Product Change Notification / GBNG-30ZMTP819

CCB 4284 Final Notice: Qualification of GTK as a new assembly site for selected SST39VF640xxx and SST39VF320xxx device families available in 48L TSOP (12x20mm) package.

CCB 4284
Pre and Post Change Summary
PCN #: GBNG-30ZMTP819

LPI

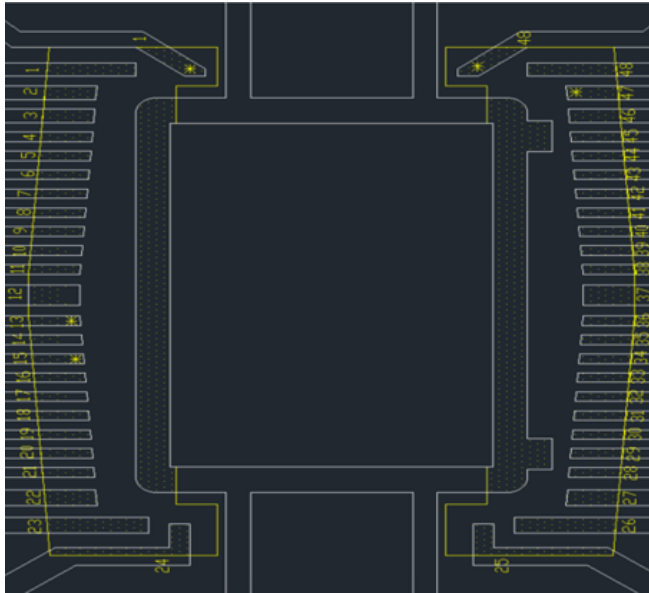
Paddle size	276 x 350 or 190 x 250 mils
Lead Lock	No
DAP Surface Prep	Double ring plating

GTK

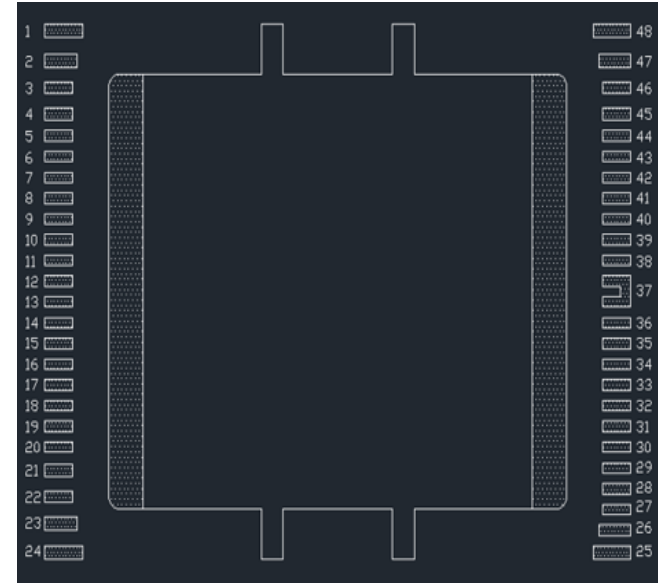
Paddle size	330 x 260 mils
Lead Lock	No
DAP Surface Prep	Ring plating
